November 24, 2025

OHIO RIVER TUNNEL

ADDENDUM No. 7

• REVISED O07-CI-702 (Sheet 582 of 770) (1 page) *Addendum No. 7*

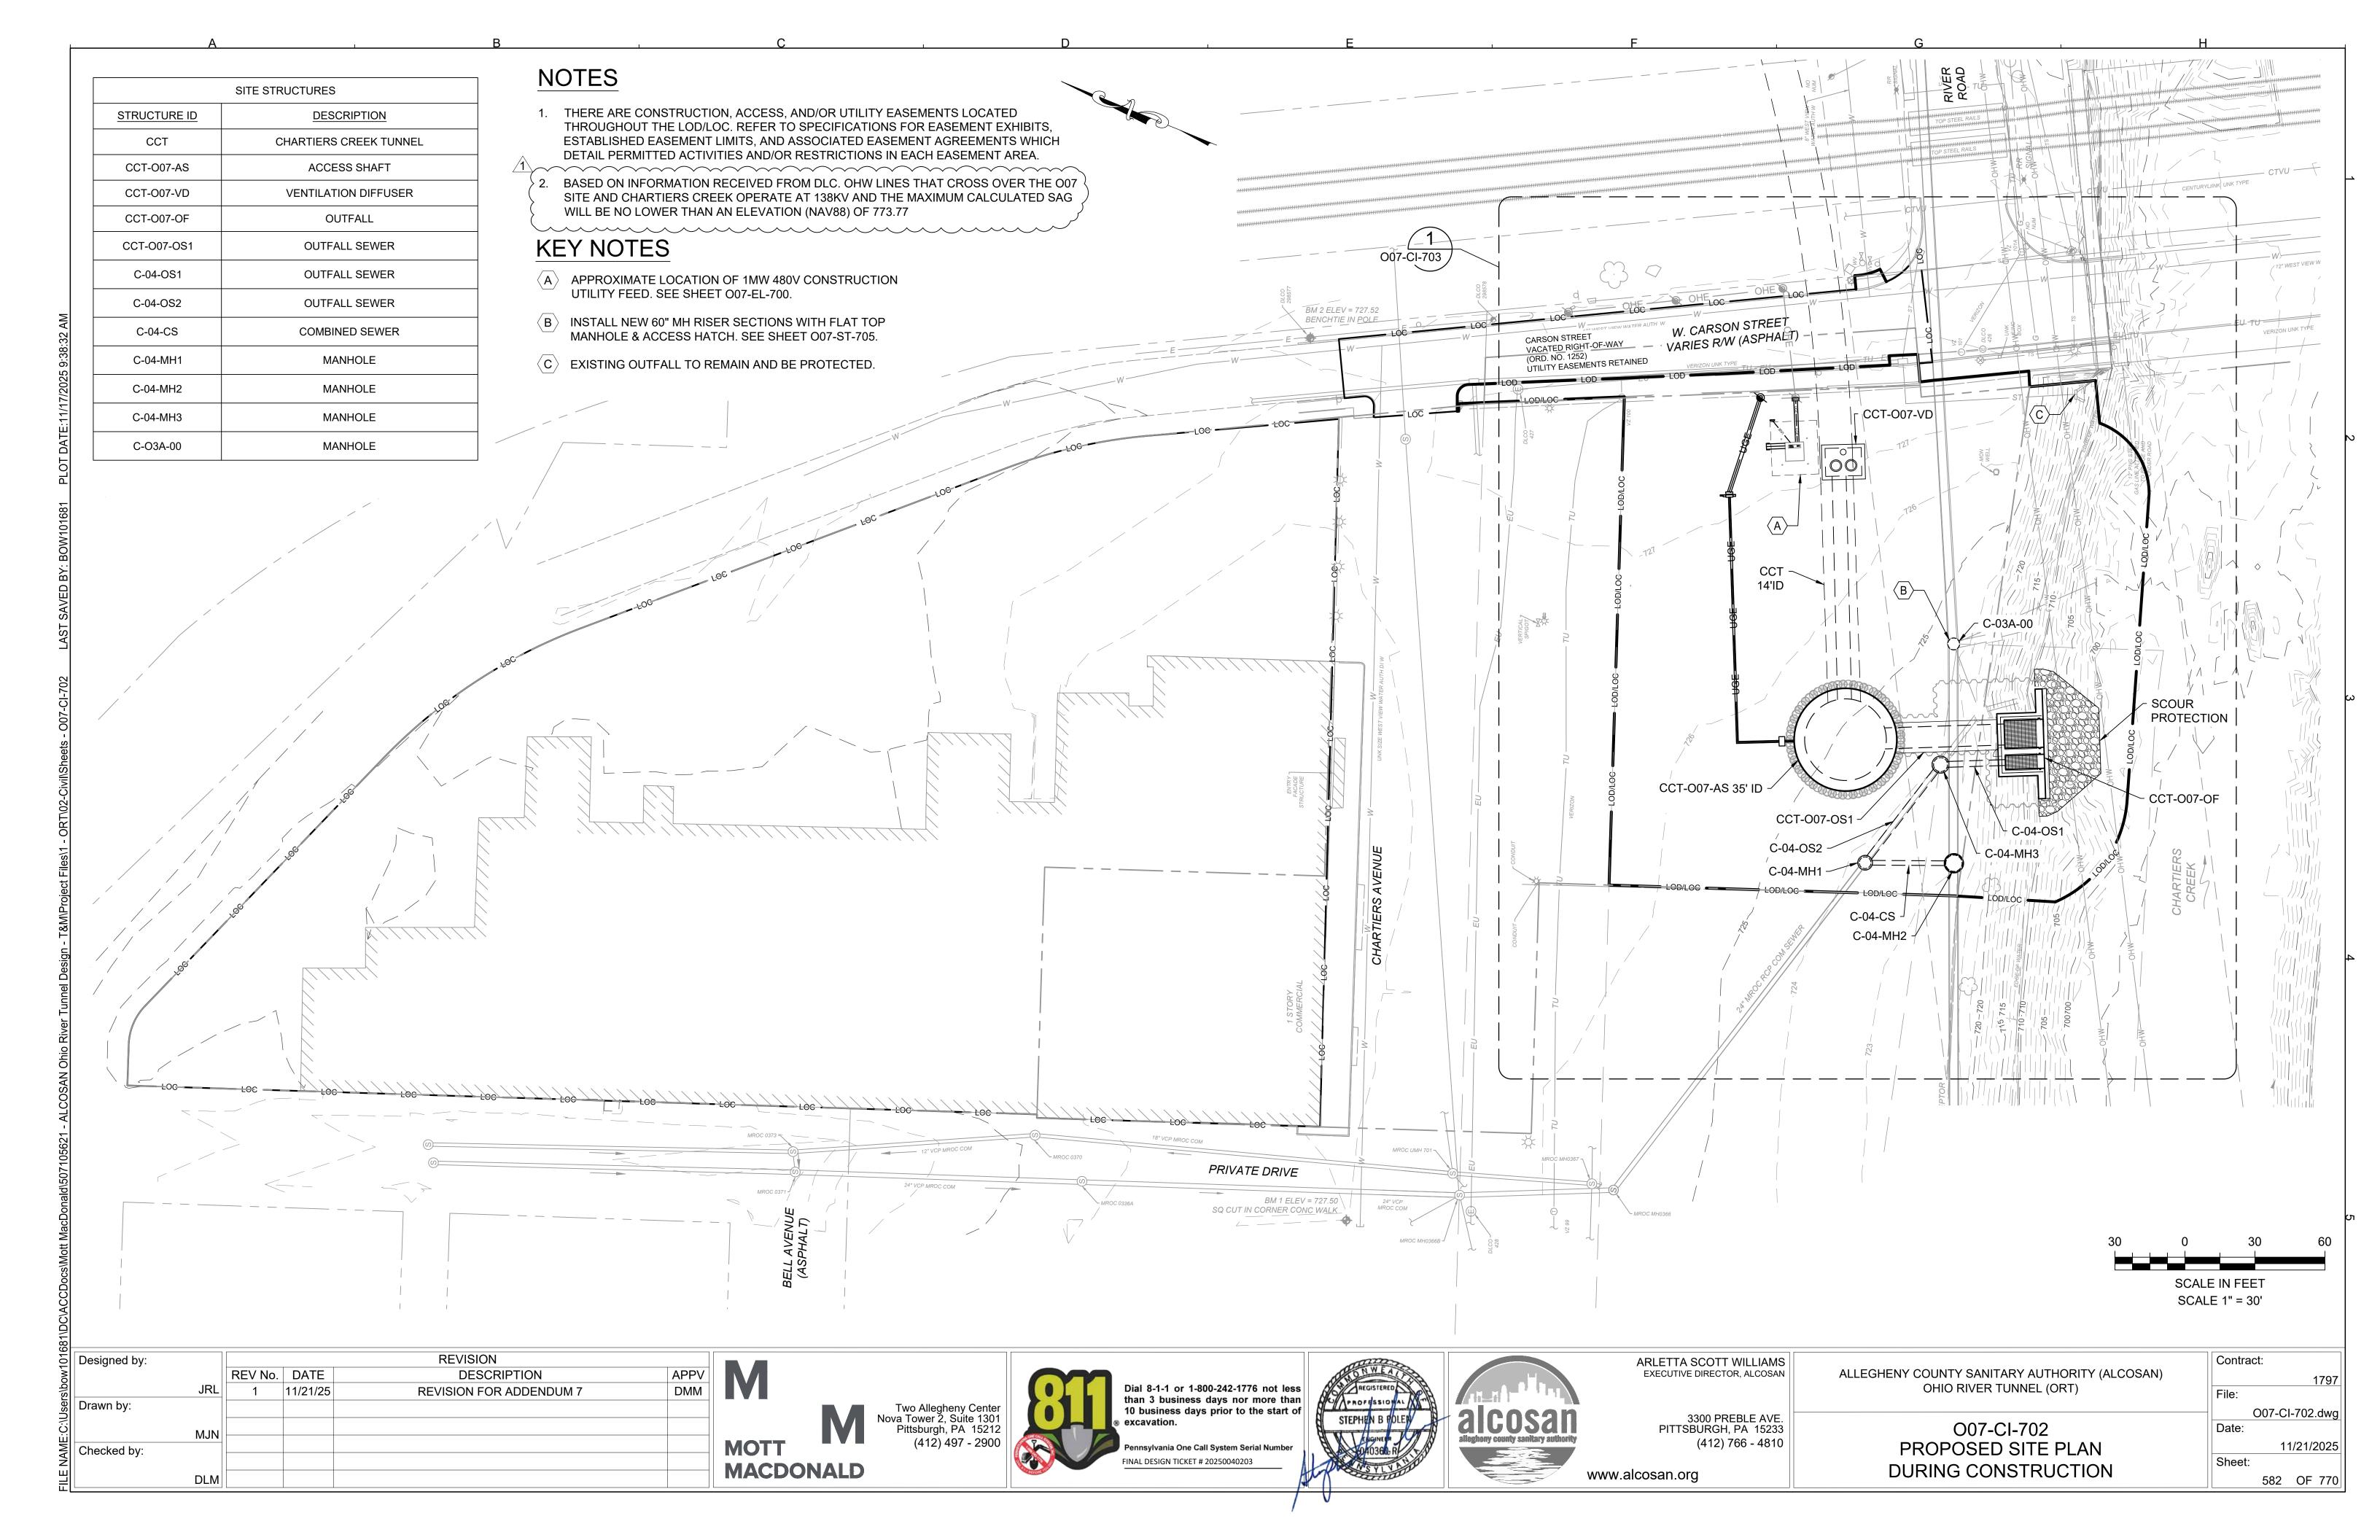
- Q3 Please provide the voltage and overhead clearance of the OHW running over the proposed outfall scour protection that parallels Chartiers Creek.
- A3 The Chartiers Creek overhead line in the vicinity of the O07 site outfall is installed between the Duquesne Light Company (DLC) towers located at the following northing and easting (NAD83 Pennsylvania State Plane South). Towers 6870 and 6872 are located outside of the O07 site Limit of Disturbance.

138kV. See Section B, Item 3 - CHANGES TO CONTRACT DOCUMENTS for REVISED 007-CI-702.

- 3. APPENDIX B CONTRACT DRAWINGS
 - a) DELETE O07-CI-702 (Sheet 582 of 770) and ADD REVISED O07-CI-702 (Sheet 582 of 770) which is Attachment C to this Addendum.
